9 SEPTEMBER, 1994

BULLETIN.113

## CP38 DISPLAY RESETTING FAULT

Check this capacitor

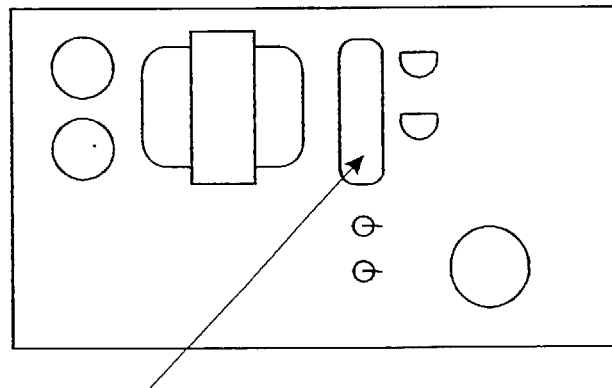
There have been several instances recently reported of CP38 CDT 450's frequently resetting back to 0.6 Carbon Steel Schedule. In many cases this has resulted from fracture (probably due to vibration fatigue) of at least one lead of a capacitor which is part of the inverter assembly which drives the LCD screen backlight. The capacitor is shown in the diagram below.

Field repair is possible, but requires the careful desoldering of the inverter module from the CP38-11 pcb in order to gain access to the capacitor terminations. Following repair, the capacitor should be supported by the application of hot-melt glue or silicon sealant between the capacitor and adjacent components.
